APPENDIX D

COORDINATION DOCUMENTATION

Coordination Correspondence

Subject: REQUESTING COMMENT - Proposed Temporary Deviation From Current Water Management Operations at Buford Dam to Reduce Water Quality Releases

Figure 4

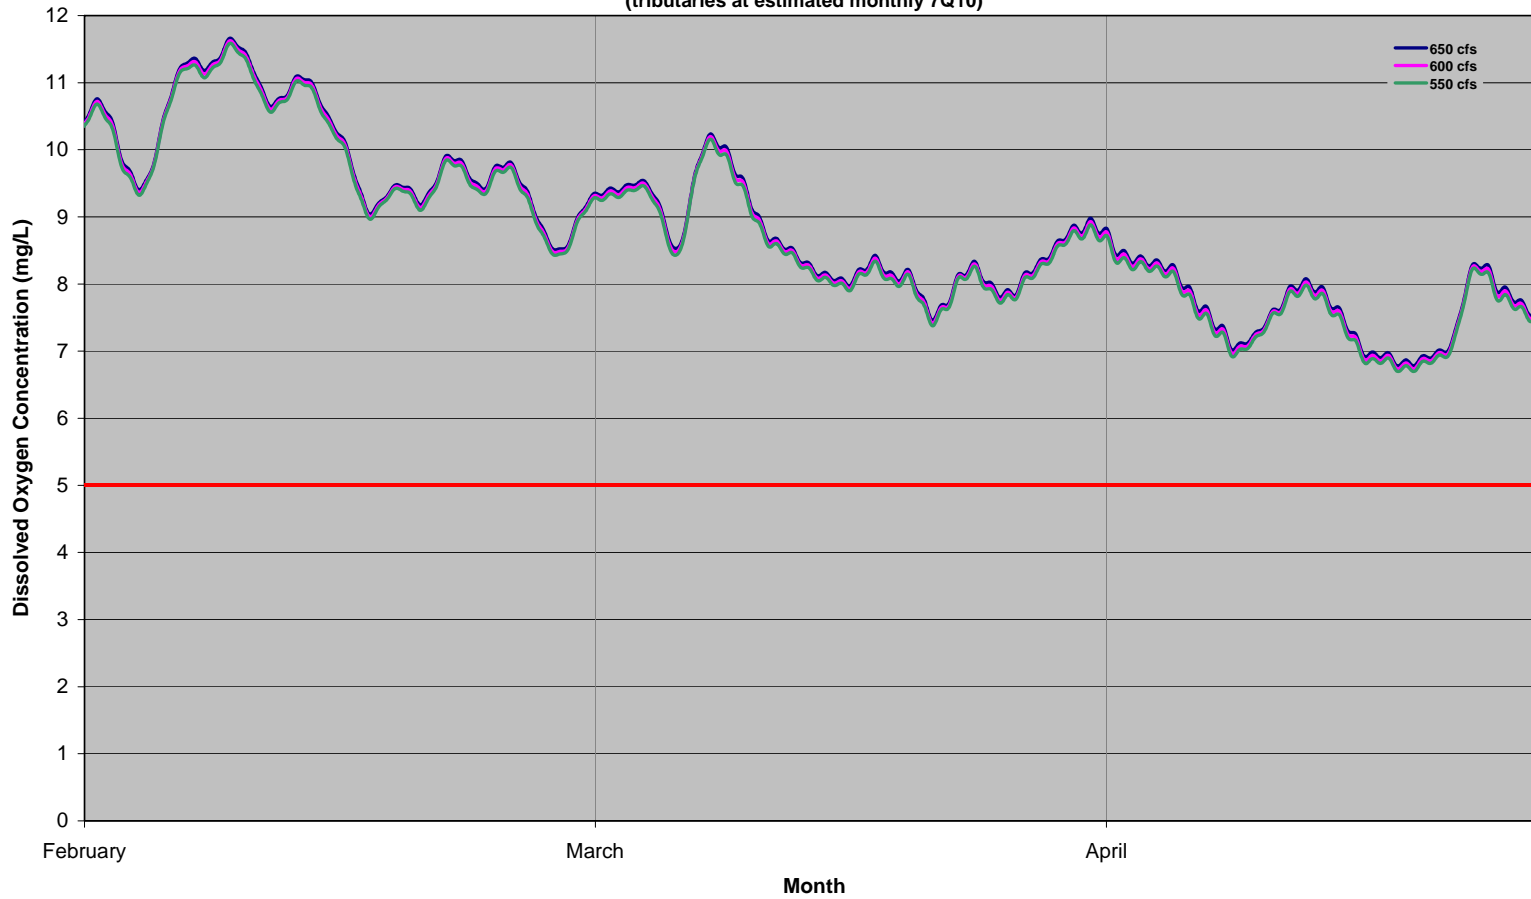
(1) Presentation of modeling input and results for DO as referenced in your 11 Feb 2008 letter. Modeling input and results should also be presented for Ammonia Toxicity and Whole Effluent Toxicity (WET) at the same incremental flows.

On Friday, we also uploaded the Chattahoochee River model files used to evaluate reduced minimum streamflows at Peachtree Creek to the ftp.planetwater.com site under username savepdepa and directory 'Files For JMG'. We also notified Jim Greenfield at EPA of the availability of these files on the ftp site.

Figure 5

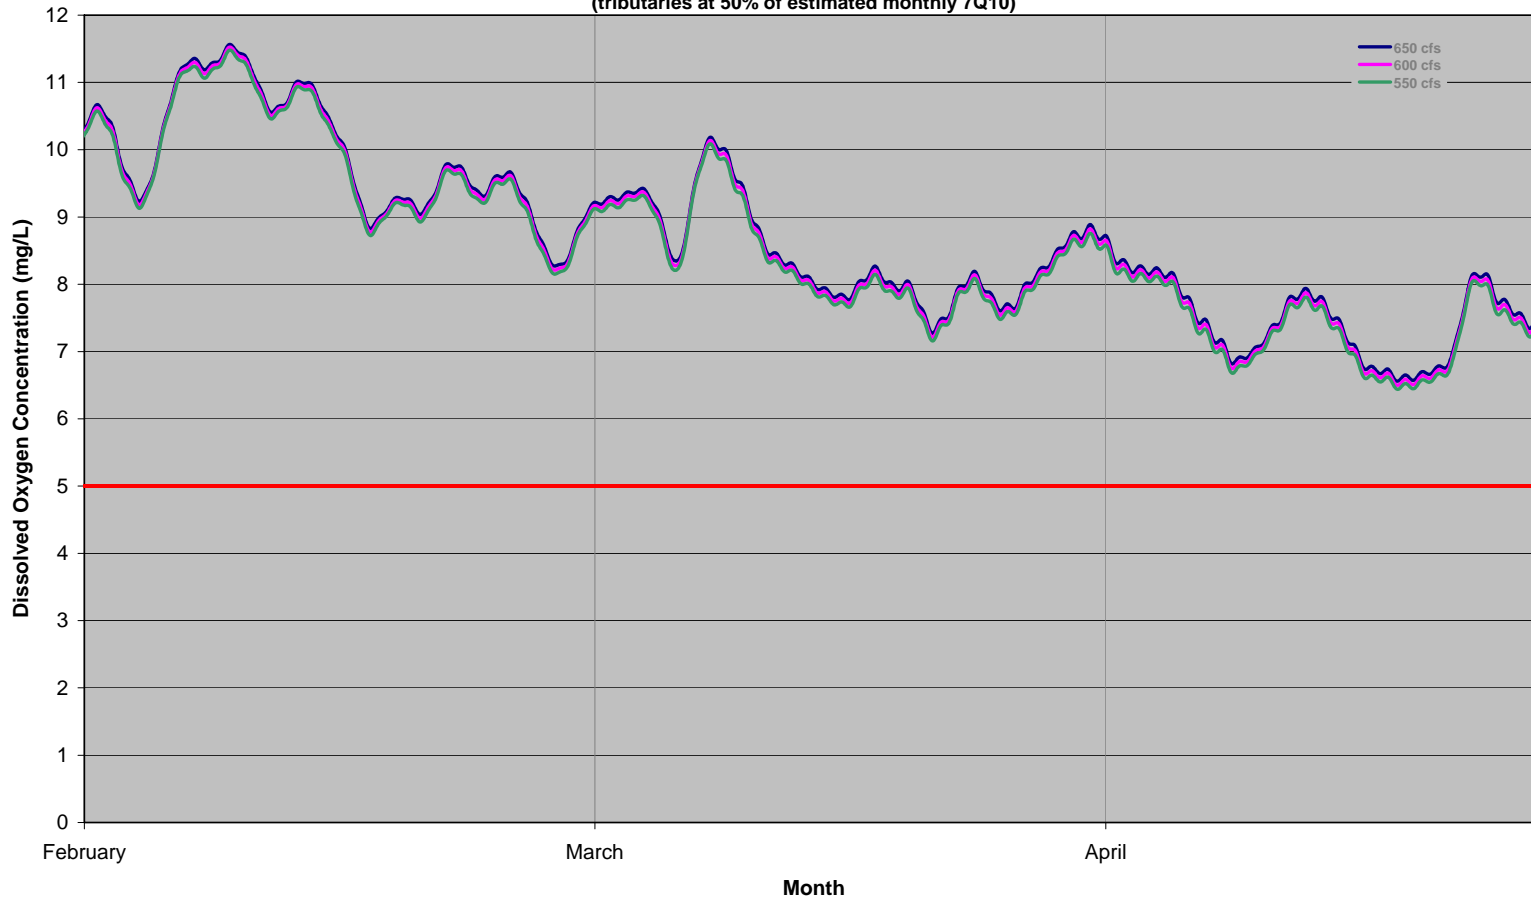
We also request clarification of the current request in relation to the modeling results presented. It appears that the modeling was conducted to assess impacts of maintaining the reduced minimum flow above Peachtree Creek for all of 2008, but the request in your letter is to temporarily reduce minimum flow for the cooler months through 30 April 2008. It is unclear if the stated benefits to Lake Lanier of the reduced flow only accrue if operated at reduced releases for all of 2008, or what the benefits would be if the reduced releases only occur through 30 April 2008. Impacts and benefits should be presented for the reduced releases occurring only during the temporary period through 30 April. Impacts and benefits should also be displayed for the incremental reductions to 650 cfs and 600 cfs.

As you also requested, this is to clarify that the benefits resulting from the proposed reduction in flow would accrue only through April 30, 2008 since we have only asked for the reduction in flow through April 30, 2008. Analysis of the full year 2008 was done for informational purposes only and was not intended to be interpreted that we were requesting a reduction in flow for the entire year 2008.

Figure 6

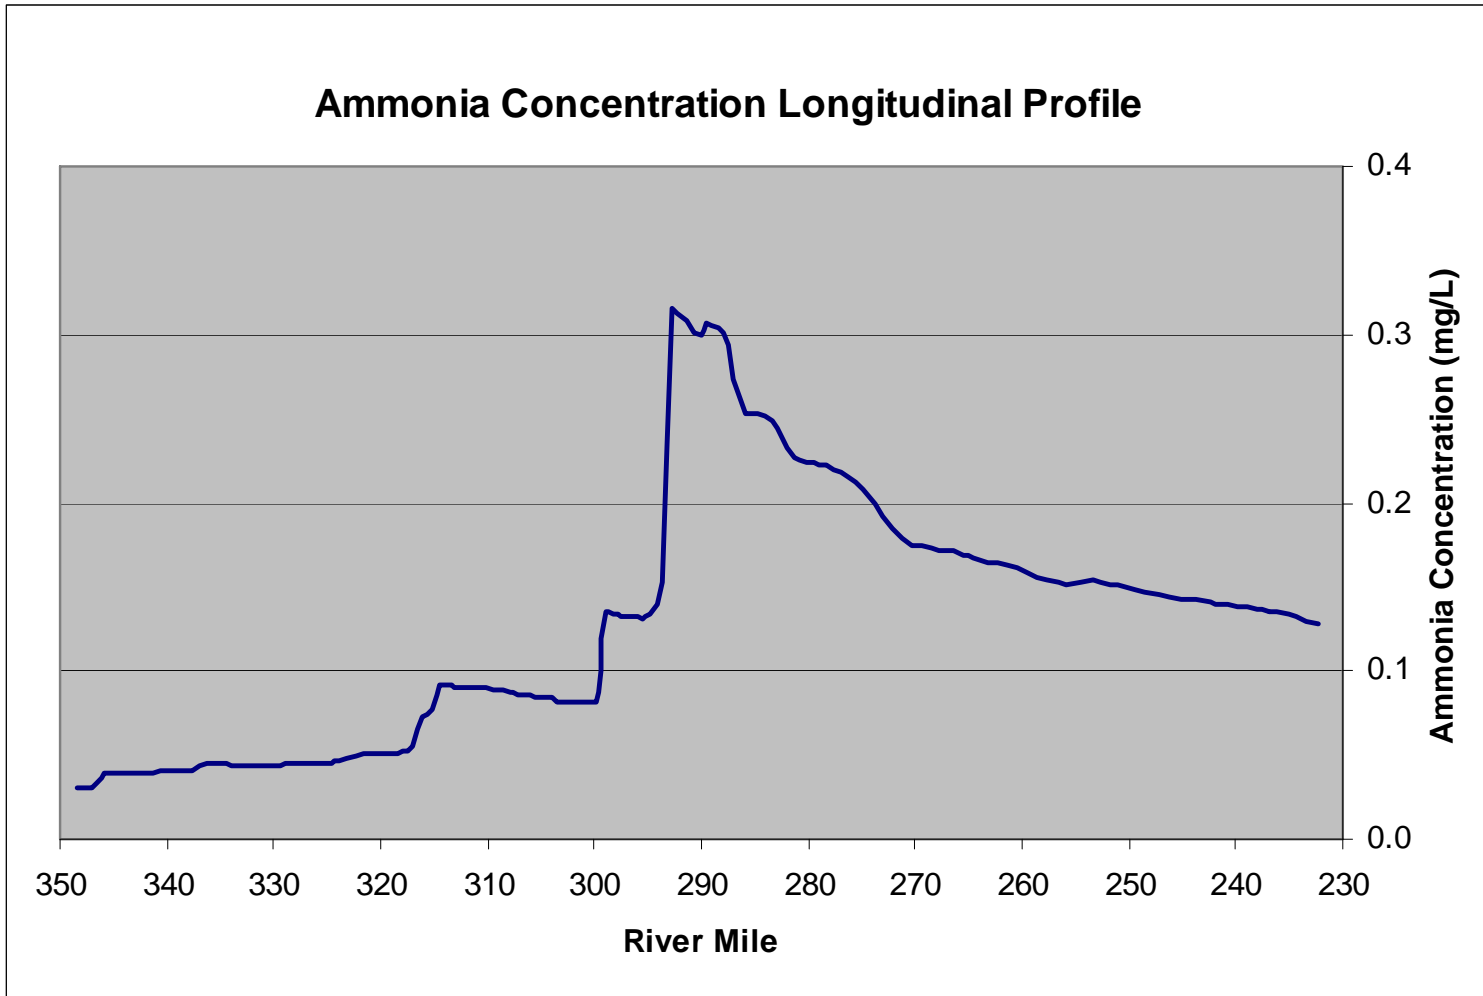
Ammonia concentration results from the water quality model were compared to computed toxicity levels according to predicted River water temperatures and pH. Figure 6 shows a longitudinal profile of ammonia concentrations at the time of the maximum concentration. Figure 7 shows the time series of ammonia concentration at the peak location shown on Figure 6. Ammonia toxicity is computed based on water temperature and pH. Predicted model water temperatures were available from the model results, however, River pH was not. Consequently, to include the effect of pH a series of pH values, 7.0 to 8.0, were assumed since toxicity increases at higher pH, and the resulting toxicity concentrations compared to the predicted ammonia concentrations. Figure 8 shows that the predicted ammonia concentrations are less than the toxic concentrations for pH as high as 8.0, which is not expected in the River.
